Reference: Modification of Existing Telecommunications Site

Install an additional wireless provider

Monterey Marriott 350 Calle Principal

Figure 1: Google Earth Photo of Site

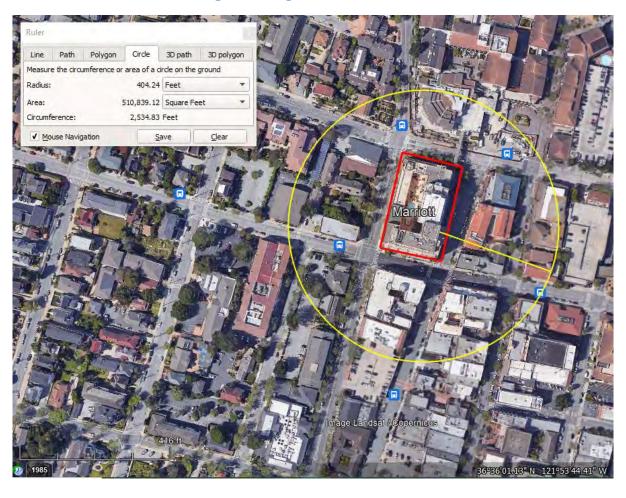
The Google Earth photo below (Figure 1) displays buildings in the area with within 400 feet of the area of study related to the proposed antenna site modification within the beam of the antenna panels might be exposed to direct radiation from Dish and the other existing wireless carriers over the FCC's guidelines for general public exposure. The yellow circle extends 400 feet from the tower. We have examined each of the buildings within that perimeter with regard to the heights/RF field intensity. We have determined that none of the buildings will be exposed to radiation above FCC guidelines for public exposure.
